Westinghouse
Electric Corporation

SUBJECT: RESPONSES TO REQUESTS FOR ADDITIONAL INFORMATION ON THE
NOTRUPM FINAL VALIDATION REPORT

Question 440.599

Figure 440.610-22

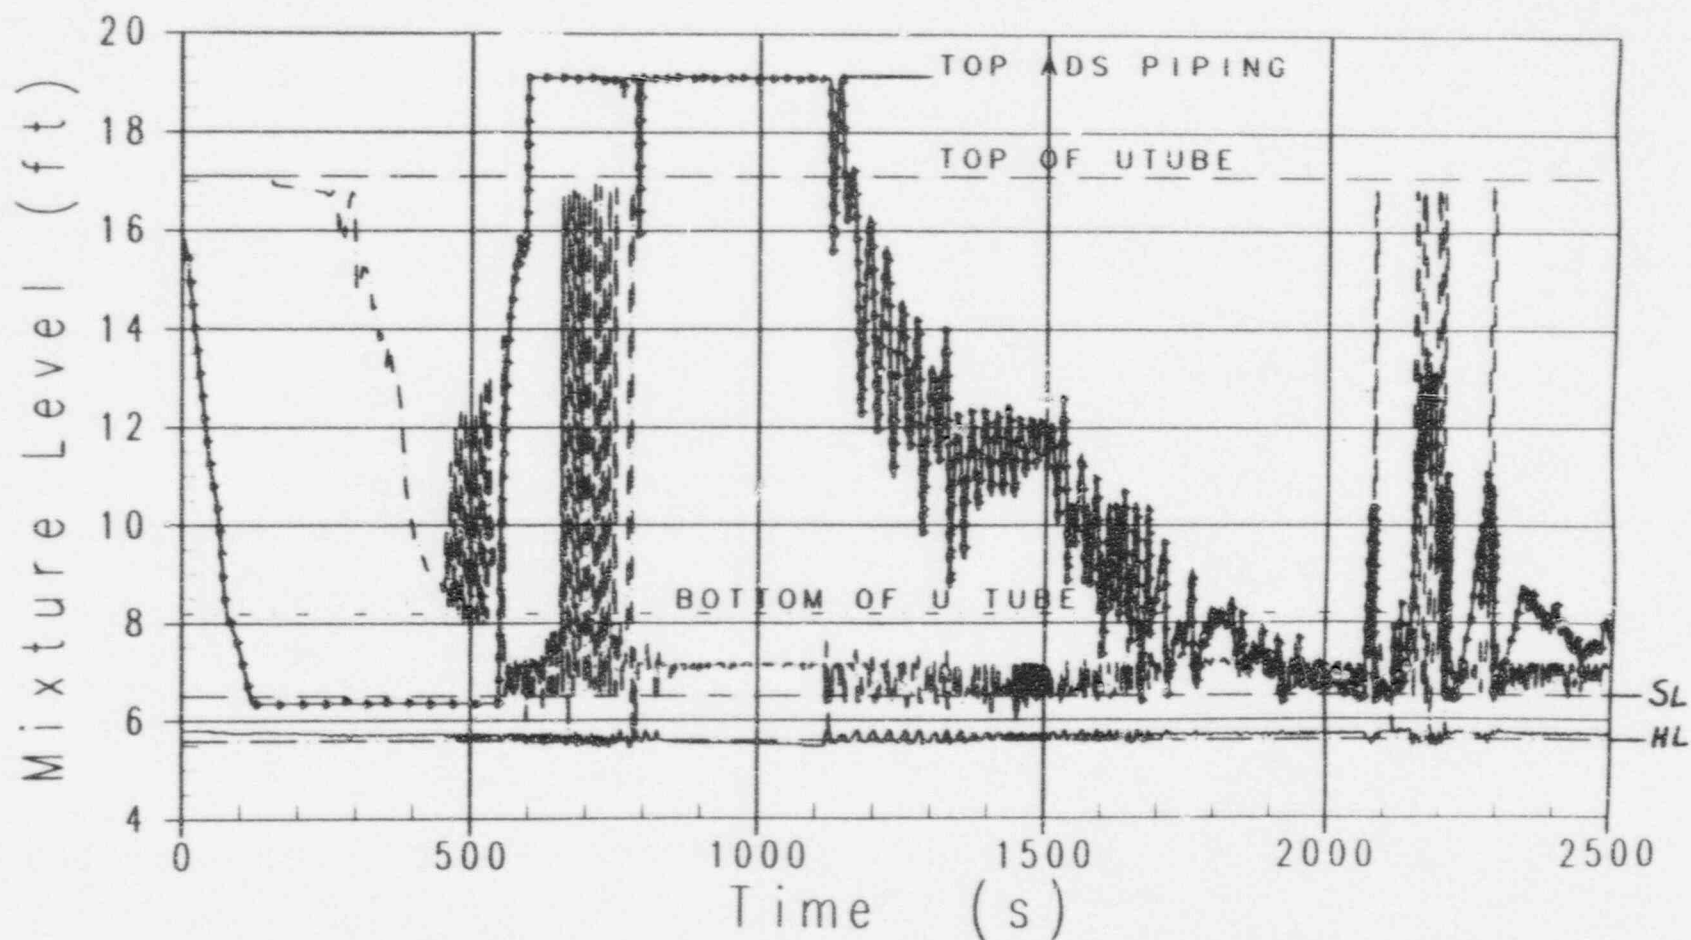
- a) At 1114 seconds, the ADS 4 valves open. The vapor generated in the core now has three main escape paths, with smaller paths through the break and the upper head. The mixture level in the pressurizer begins to drop (Figure 440.610-22). The liquid flowrate at the surge line is intermittently downward (Figure 440.610-20), as less vapor flows into the surge line (Figure 440.610-20). The time at which the pressurizer and surge line both completely drain is 2000 seconds, []^{a,b,c} than the test. Although the drain time for both the pressurizer and surge line is reasonably well predicted, the average predicted collapsed liquid level in the pressurizer is lower. In the test, the void fraction in the surge line is relatively high, about []^{a,b,c} percent (Figure 440.610-16), indicating continued vapor flow through ADS 1-3 in the test (as supported by the fractional estimates given previously). In the NOTRUMP prediction, the pressurizer mixture void fraction approaches one (Figure 440.610-25), as does the vapor flow through ADS 1-3 (Figure 440.610-23).

The mixture level in steam generator 2 (SG-2) rises into the tubes on the hot leg side at about 650 seconds as discussed in the response to RAI 440.610 (see Figure 440.610-17). This causes reverse heat transfer in the secondary side and a corresponding drop in the secondary side temperature, seen in Figure 8.3.1-38. The later drop in the temperatures for both SGs (between 2150 and 2200 seconds) occurs following IRWST injection, when there is a second rise in the mixture level in the SG tubes. This is shown on Figure 440.610-22 for SG-2. A similar level rise is also predicted in SG-1 at the same time.

Figure 440.644-1

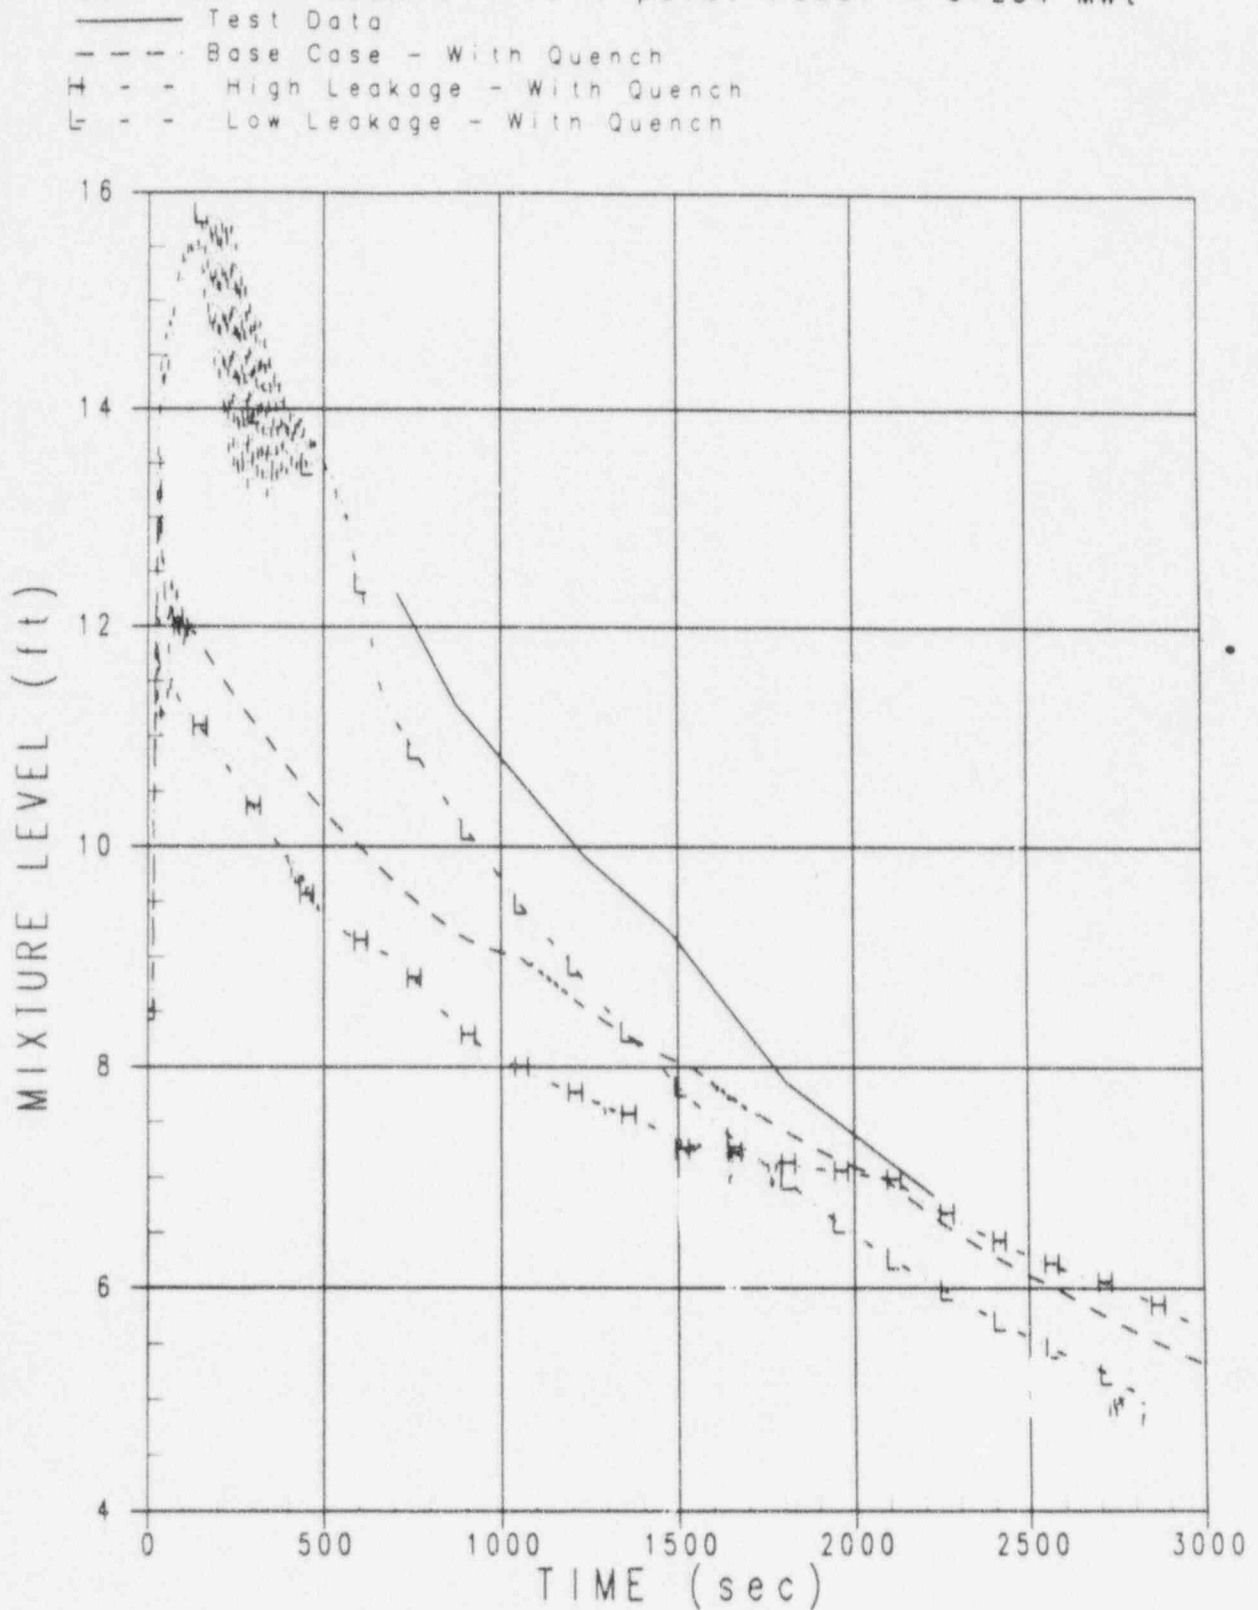
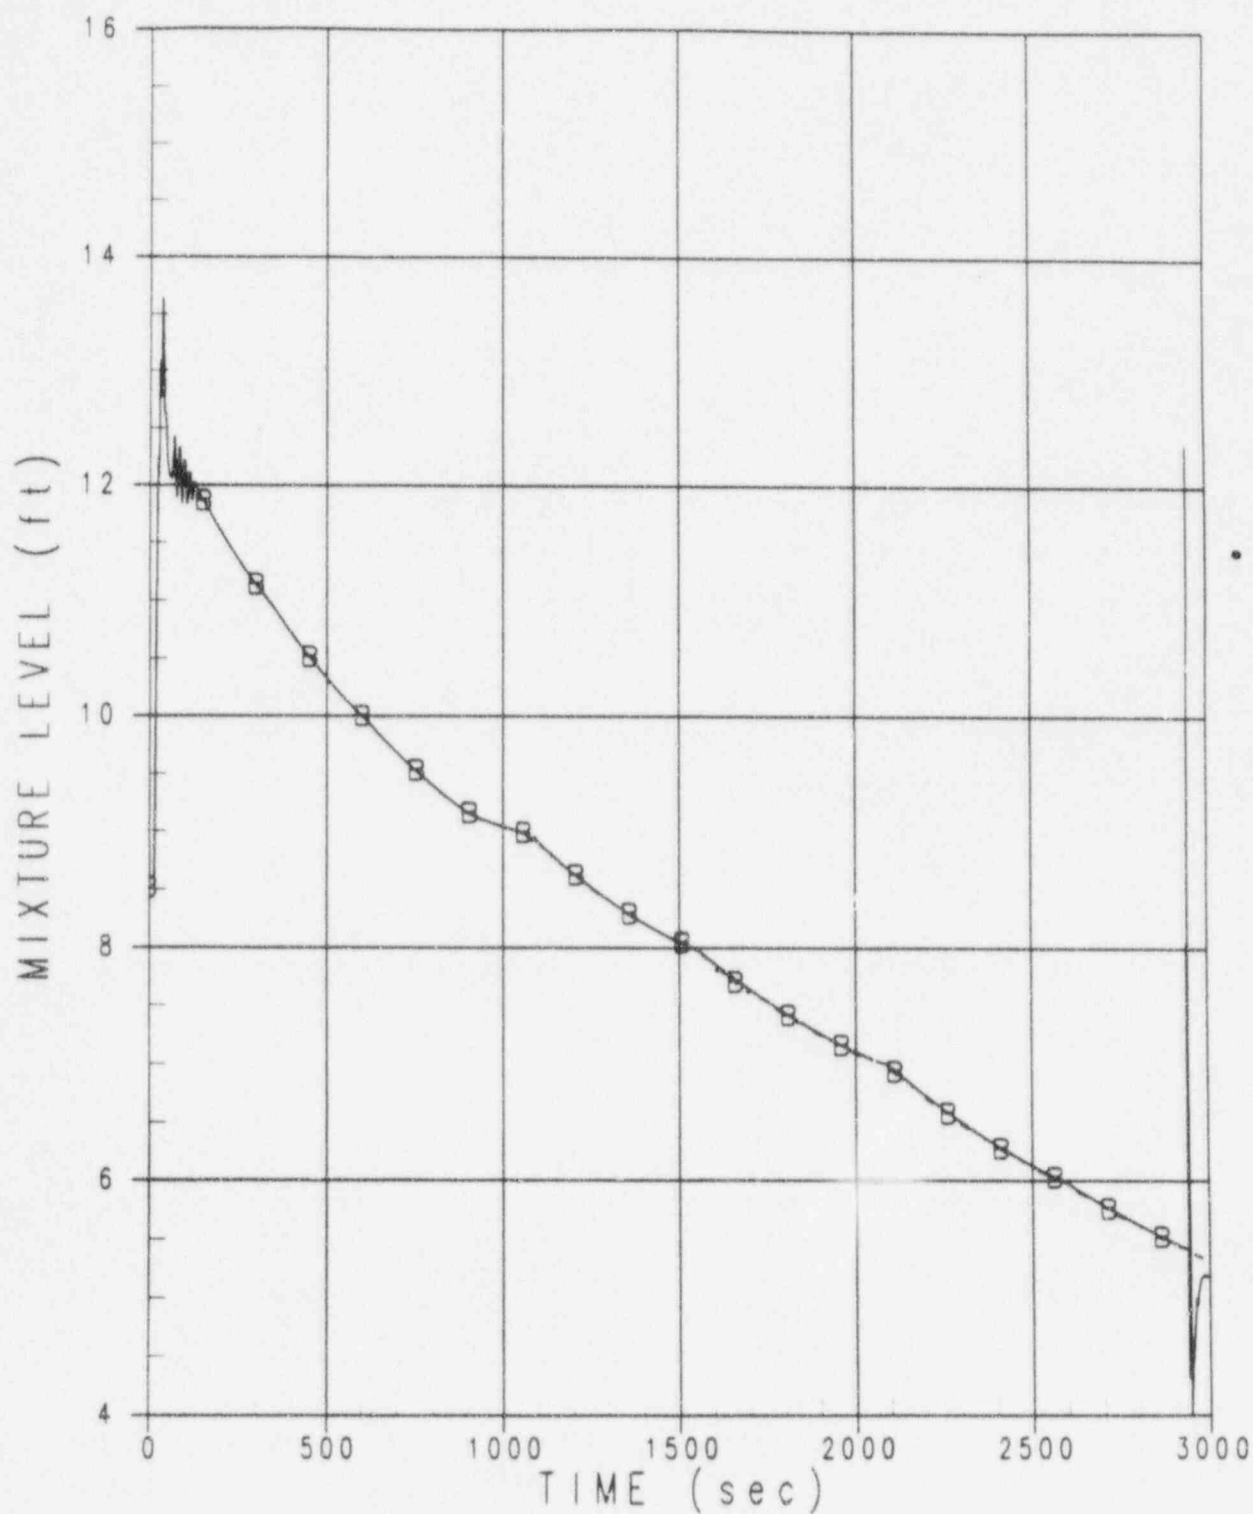
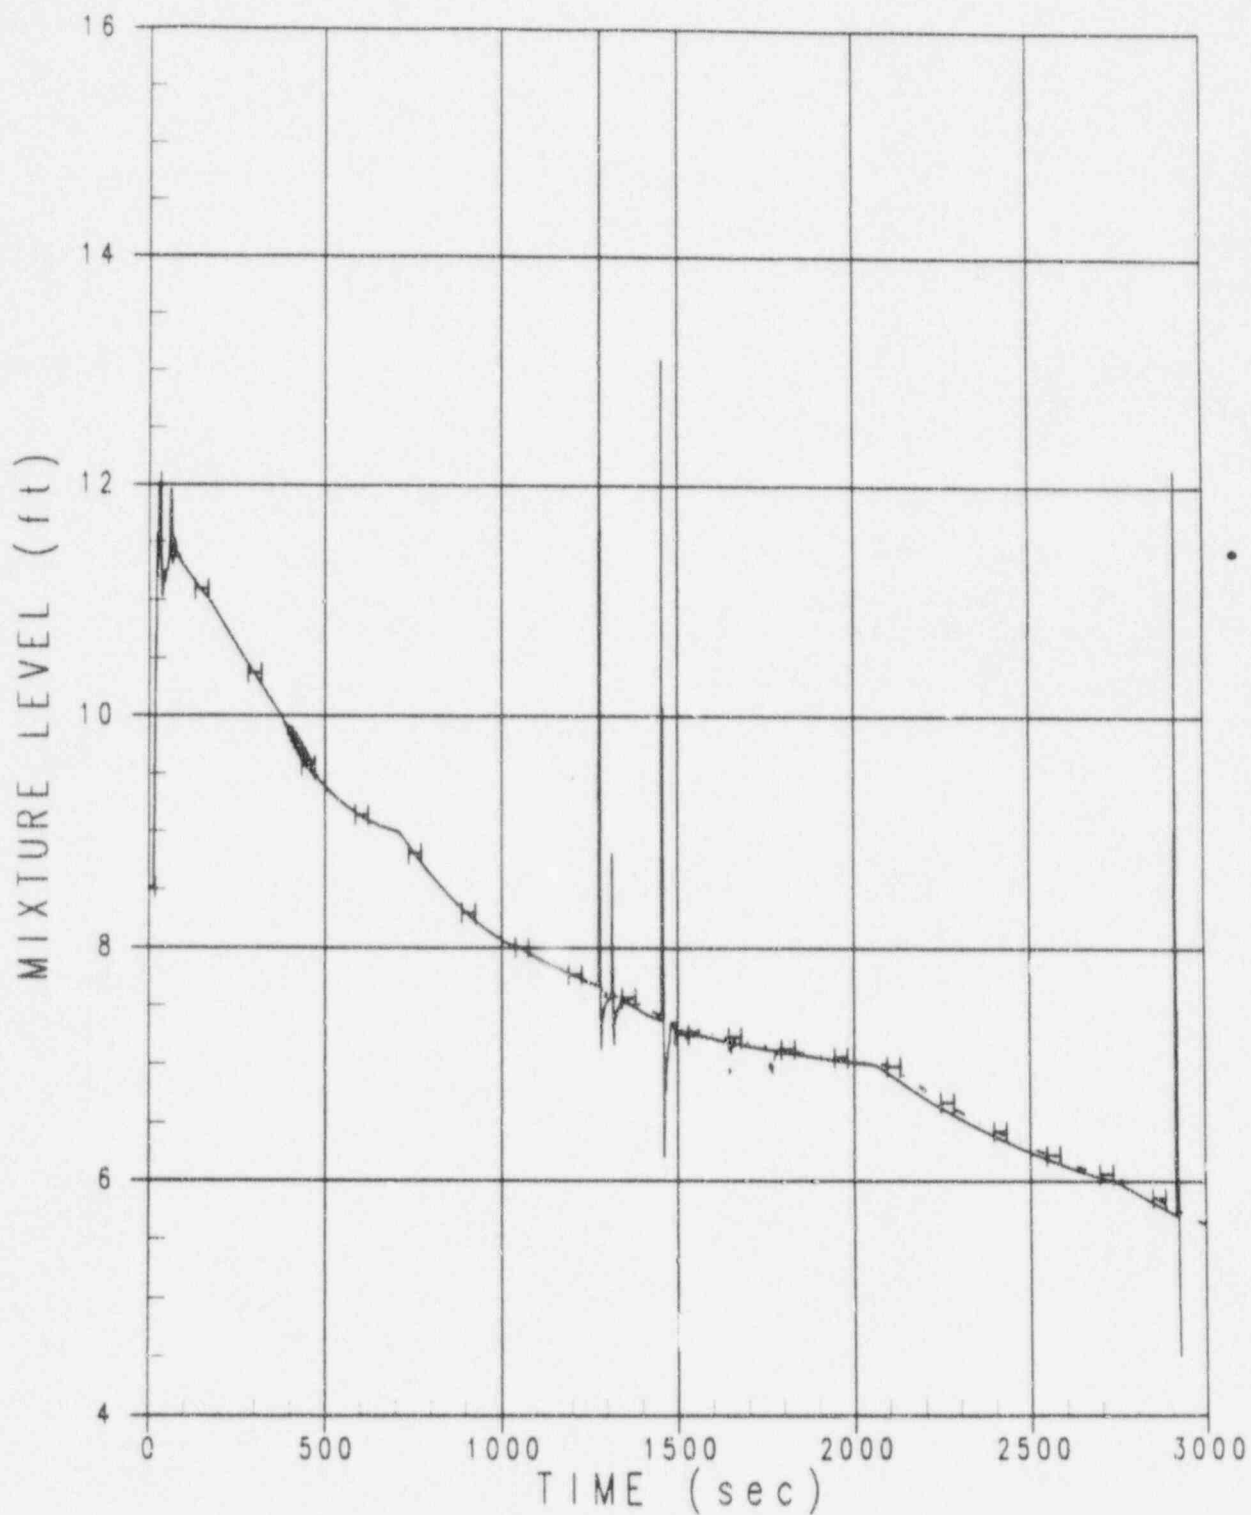
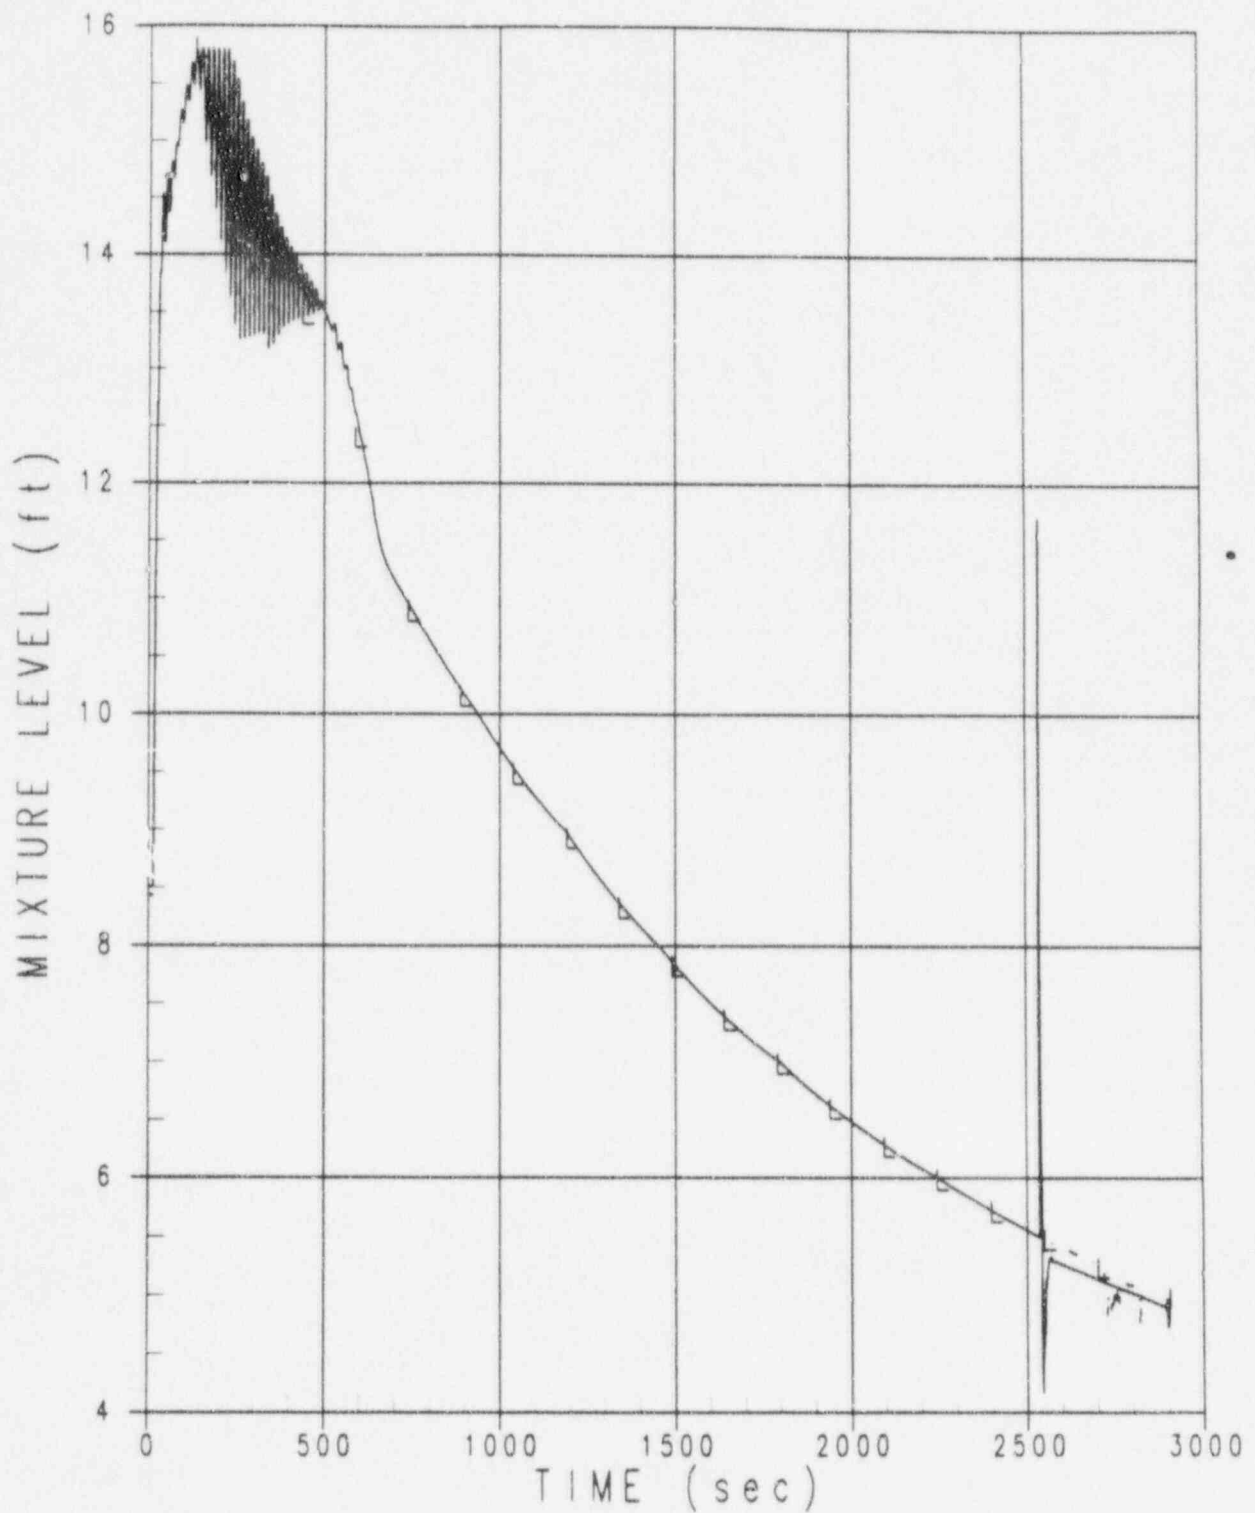
- A. For the G2 level tests (Tests 723, 729, 732 and 733) that utilized the core quench model, the mixture level plots (Figures 4.4-29 through 4.4-32 of Reference 440.644-2) will be revised to include results of the NOTRUMP simulations with and without the quench model. The text on pages 4.4-13 (last paragraph of Section 4.4.8.1) and 4.4-16 (first four paragraphs) of Reference 440.644-2 will also be revised to indicate the use of the core quench model for these tests. A sample set of plots are given in Figures 440.644-1, 440.644-1A, 440.644-1B, and 440.644-1C.
